Submission to An Coimisiún Pleanála  
64 Marlborough Street, Dublin 1, D01 V902

Planning Reference Number: PAX07.323699 - RWE Renewables Ireland Limited - 11 no.  
turbine wind farm and associated infrastructure

I would like lodge a formal objection in respect to the proposed Shancloon Windfarm  
Development SID (Case 323699)

Image Bing Maps

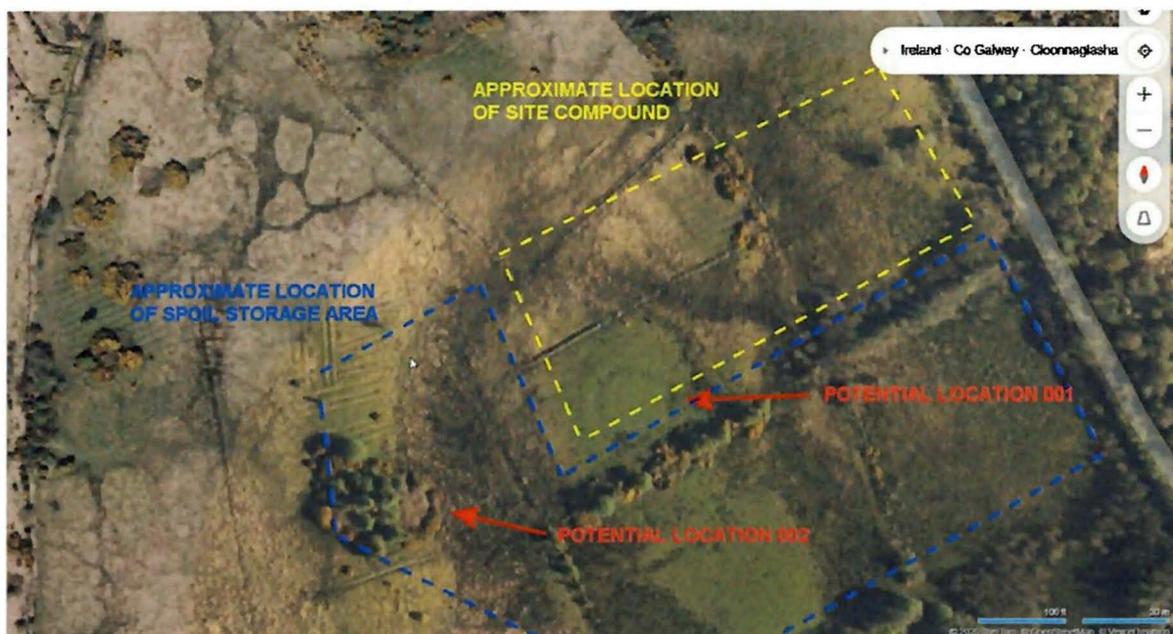
The last issue of concern I would like to highlight is that the location of the proposed site compound, based on maps published both online and in literature published by RWE, is outside the study area indicated in the published maps. From our own studies of the site compound using roadside and online aerial imagery we believe that the site could also contain two undiscovered archeological sites as shown in the image below. These potential sites have been notified to national monuments for consideration.
